# PARASITIC ENGINEERING

PARASITIC ENGINEERING CLOCK FIX KIT INSTRUCTIONS

## Addendum to Clock Fix Kit

We have recently made a slight modification of our clock generator circuit. This change improves circuit performance if the Altair's 2 MHz crystal is weak.

FIGURE A

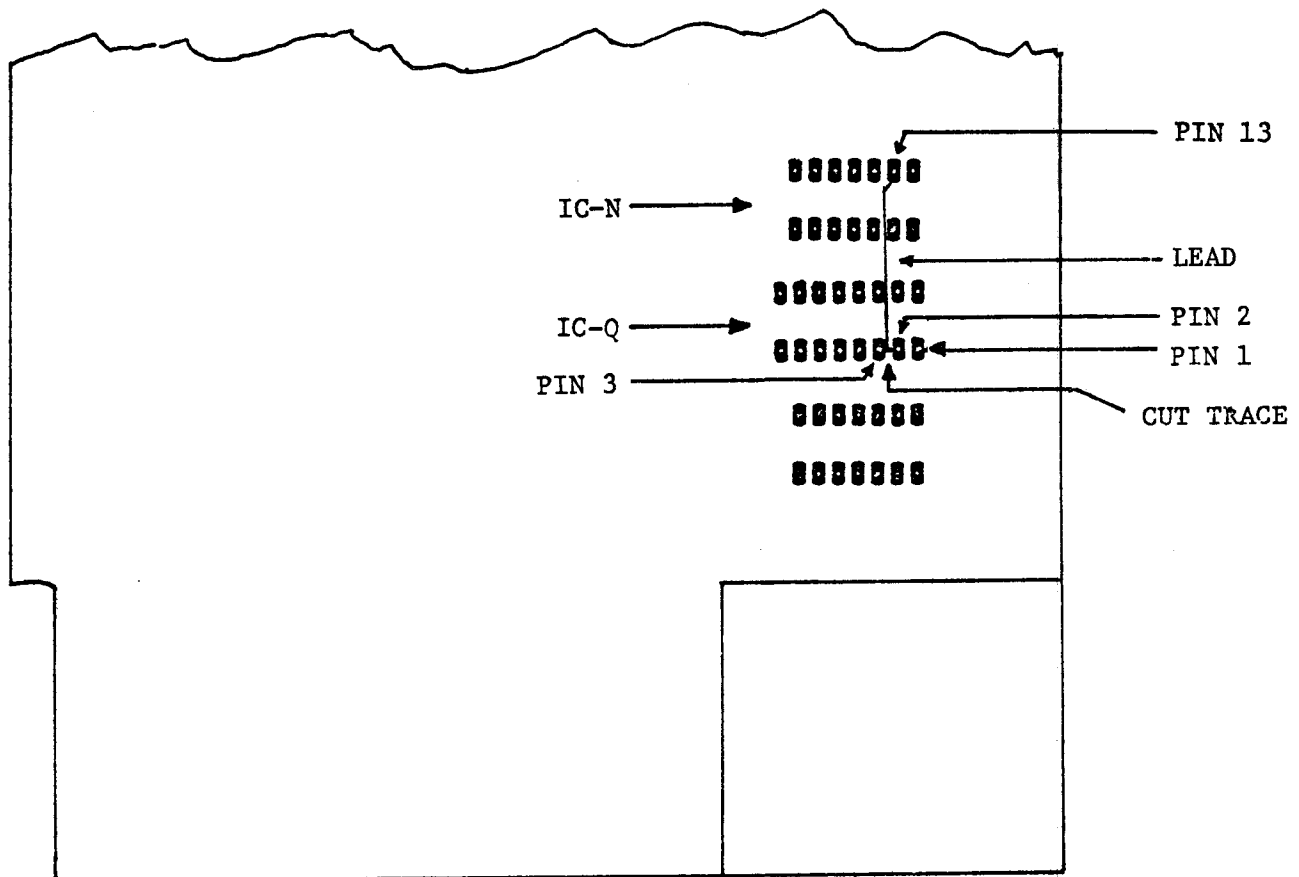
- ( ) Locate pins 2 & 3 of IC-Q on the C.P.U. board. See figure A. Cut the trace between these two pins.
- ( ) Take the 1" bare wire plus insulation supplied with this addendum. Solder one end of this wire to pin 3 of IC-Q.
- ( ) Solder the other end of the wire to pin 13 of IC-N.
